Reference No. 17-0030

This letter is in response to your February 24, 2017, email requesting clarification of the Hazardous Materials Regulations (HMR; 49 CFR Parts 171-180) applicable to the general requirements for shipment of compressed gases and other hazardous materials in cylinders, United Nations pressure receptacles, and spherical pressure vessels. You include a diagram of a manifolded cylinder system and specifically seek confirmation of your understanding that the regulations in § 173.301(g) would allow the quarter turn valve or shutoff valve to remain in the open position if an air operated valve (AOV) is closed while the cylinders are manifolded in transportation.

Regulation reference: 49 CFR 173.301 General requirements for shipment of compressed gases and other hazardous materials in cylinders, UN pressure receptacles and spherical pressure vessels...

Figure 1

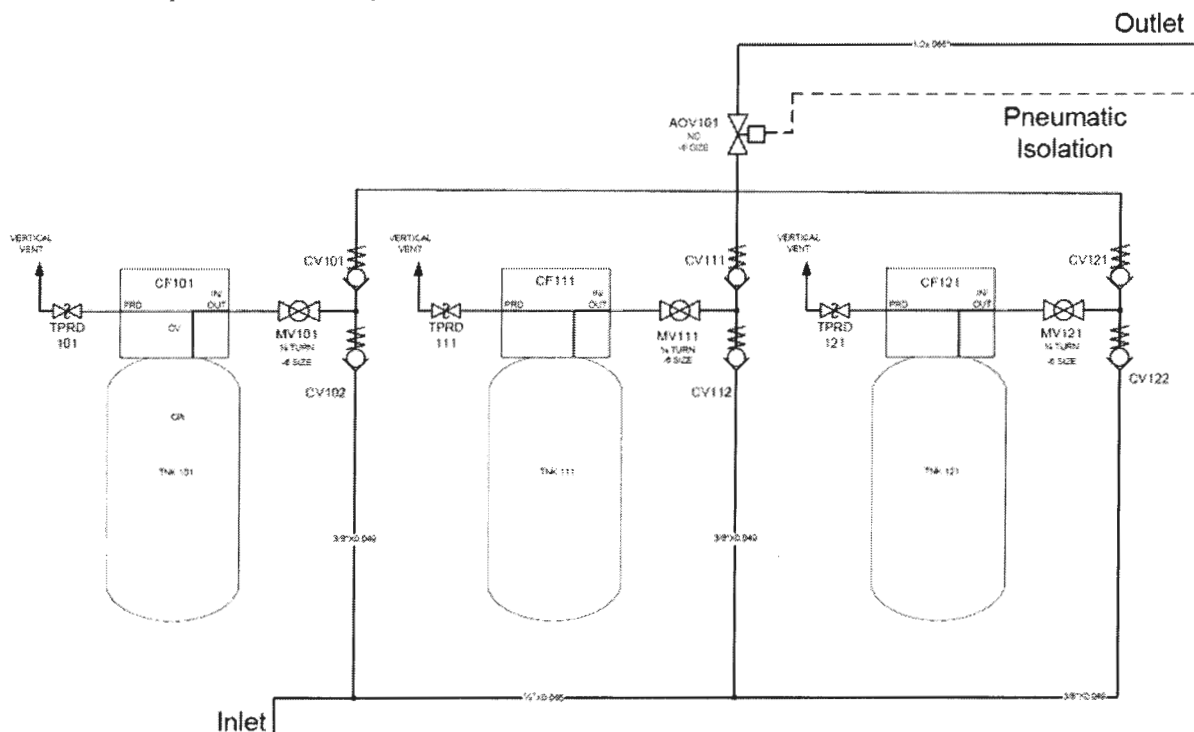
Our interpretation of this regulation would allow for the use of a system design as shown in the diagram below, figure 1. This diagram represents the plumbing on each row of cylinders within the trailer. There may be up to 17 rows of cylinders per trailer, refer to figure 2 on the next page. The intent is to leave the ¼ turn valve in the open position but close the air actuated valve for transportation. The inlet check valves close the inlet lines from the cylinders. The outlet check valves isolate the contents of each cylinder. The air actuated valve closes the cylinders off from the outlet lines. There would be one air actuated valve per row of three cylinders.

- TPRD 101, 111, 121 are thermally activated pressure relief device.
- TNK 101, 111, 121 are pressure tanks
- CF 101, 111, 121 are tank heads
- MV 101, 111, 121 are manual ¼ turn valves
- CV 101, 111, 121, 102, 112, 122 are check valves
- ADV101 is an air actuated valve.

Your understanding is not correct. According to § 173.301(g), each cylinder must be equipped with an individual shutoff valve that must be tightly closed while in transit, except cylinders containing a Division 2.2 material. While your original email did not specify the primary material being filled inside the cylinders, you explained in a subsequent email and phone conversation with a member of my staff that it would be either a Division 2.1 or Division 2.2 material. The individual shutoff valve for cylinders filled with a Division 2.1 material cannot remain open while in transit even if an AOV is installed. However, cylinders filled with a Division 2.2 material are not subject to the individual shutoff valve requirements and can remain in the open position while in transit.

In addition, the HMR do not prohibit the use of an AOV installed on manifolded cylinder systems. However, in order to use an AOV while transporting a Division 2.1 material in the manner you describe, you must submit an application for a Special Permit.
